## **Section 42A Report to the District Plan Review Hearing Panel**

### **Proposed Horowhenua District Plan Land Transport and Subdivision & Development**

Report Number: 10.01

Diagram 1: Approach Sight Triangles For Level Crossings

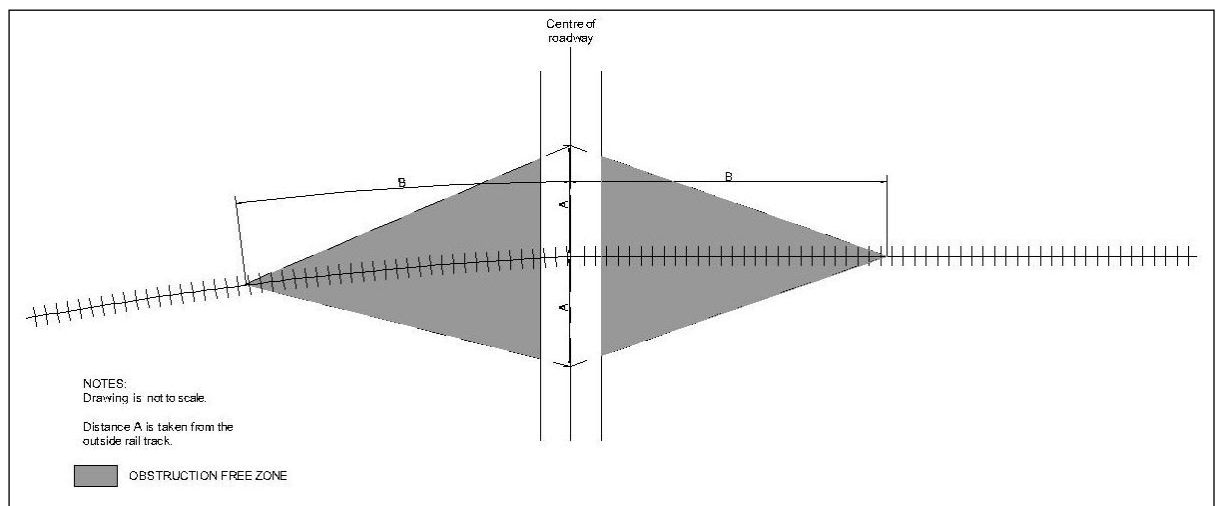
6. Safety and visibility at road and rail intersections conditions are contained in two parts of the Proposed Plan: Chapter 21 (Rule 21.1.6(c)(i)) and in each Zone Rule Chapter as a permitted activity condition (Rules 15.6.24, 16.6.16, 17.6.18, and 19.6.23, except there is an omission in the Open Space Zone). To avoid duplication, it is considered this requirement should only be contained in one part of the Proposed Plan. A Zone Chapter permitted activity condition is preferred as this requirement relates to the use and development of land, where as the standards in Chapter 21 are generally more technical requirements. Therefore, it is recommended that each Zone Chapter permitted activity condition be amended to specifically relate to road/rail intersections (i.e. level crossings) and the reference to Diagram 1 be replaced with a reference to a new Appendix in Chapter 21 (a new condition is recommended to be added to the Open Space Zone under submission point 55.33 as discussed in the Open Space Zone Section 42A Report). A new Appendix is recommended to be added to Chapter 21 as set out in the Attachment 1 to the KiwiRail submission. Lastly, it is recommended Rule 21.1.6(c)(i) be deleted. Therefore, it is recommended this

Delete Diagram 1 – Traffic Sight Lines at Road and Rail Intersections on Page 21-14.

Add a new Appendix 1: Railway Level Crossing Requirements to Chapter 21 as follows:

No new visual obstructions are permitted within the approach sight triangles (shaded areas) shown diagrammatically in Diagram 1, irrespective of whether any visual obstructions already exist. The required sight triangles to achieve this are 30 metres from the outside rail (approach distance along road) and 320 metres along the railway track.

- The dimensions in Diagrams 1 and 2 apply to a single set of rail tracks only. For each additional set of tracks, add 25 m to the along-track distance in Diagram 1, and 50 m to the along-track distance in Diagram 2.
- All figures are based on the sighting distance formula used in NZTA Traffic Control Devices Manual 2008, Part 9 Level Crossings. The formulae in this document are performance based. However, for the purpose of this rule, the parameters are fixed to enable easy application. The parameters used are:
  - A train speed of 110 kph and a single set of rail tracks
  - A vehicle approach speed of 20 kph
  - A fall of 8 % on the approach to the level crossing and a rise of 8 % at the level crossing
  - 25 m design truck
  - 90° angle between road and rail

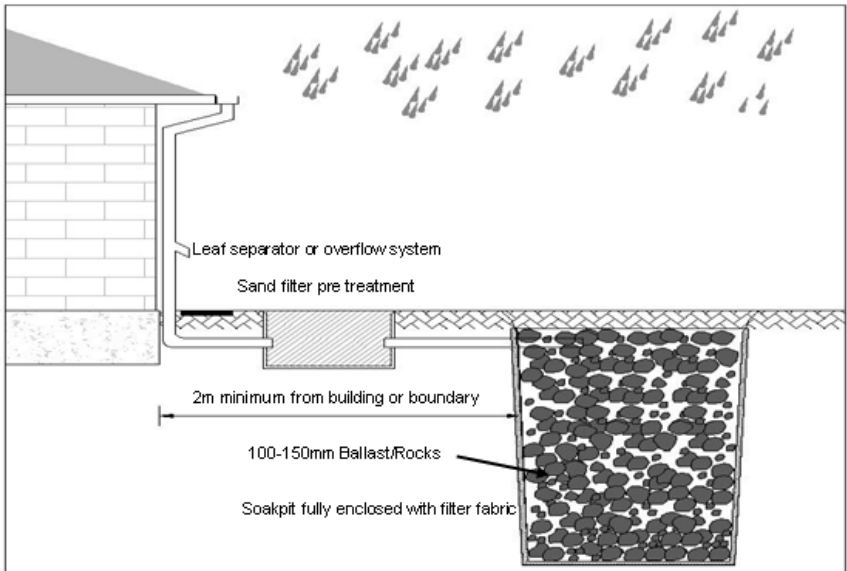
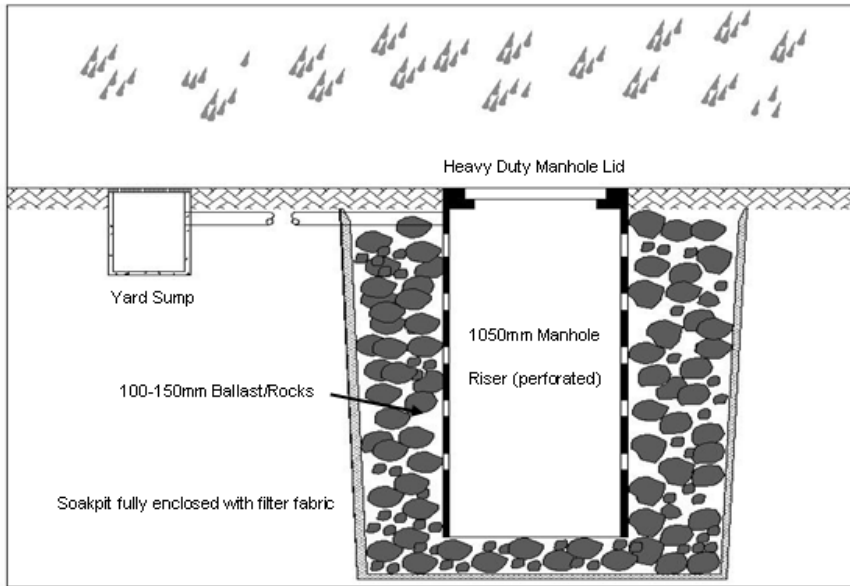
Amend the Subdivision and Development Engineering Appendix 2, Stormwater Disposal to Soakpits as follows:

Amend Section 1 "Introduction to Soakpits" by adding a new paragraph after the 5<sup>th</sup> paragraph as well as a note under the Typical Soak Pits Layout diagram.

**A =** catchment area in hectares (to include buildings, hard surfaces and ~~grassed areas~~)

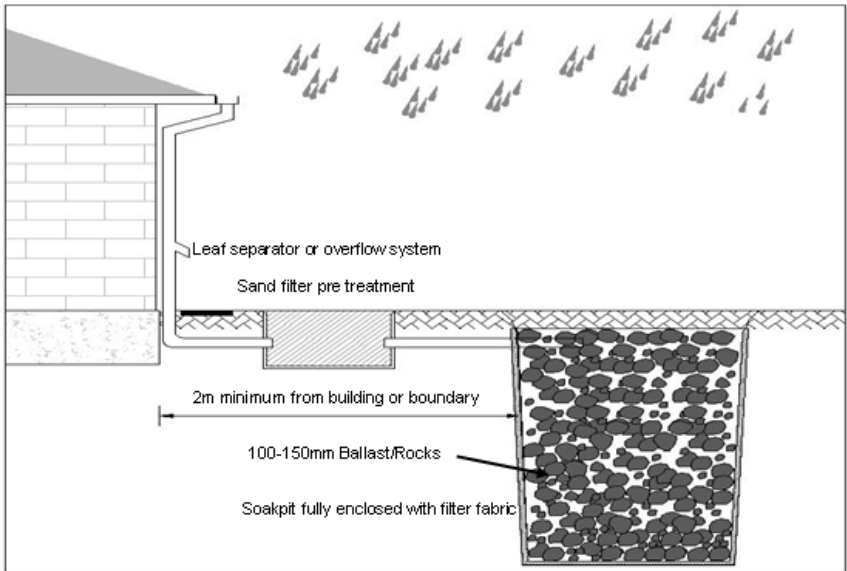
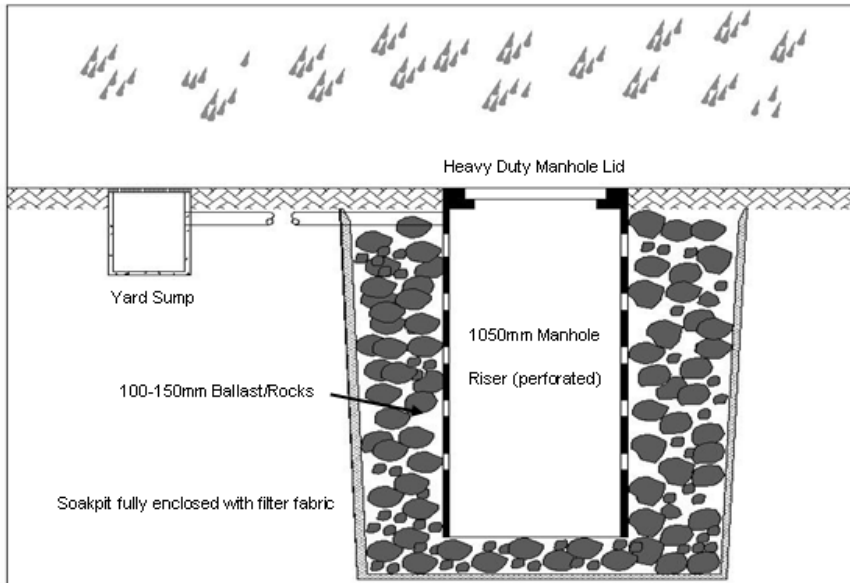
Amend the Subdivision and Development Engineering Appendix 2, Stormwater Disposal to Soakpits as follows:

Amend Section 1 “Introduction to Soakpits” by adding a new paragraph after the 5<sup>th</sup> paragraph as well as a note under the Typical Soak Pits Layout diagram.

**A =** catchment area in hectares (to include buildings, hard surfaces and ~~grassed areas~~)
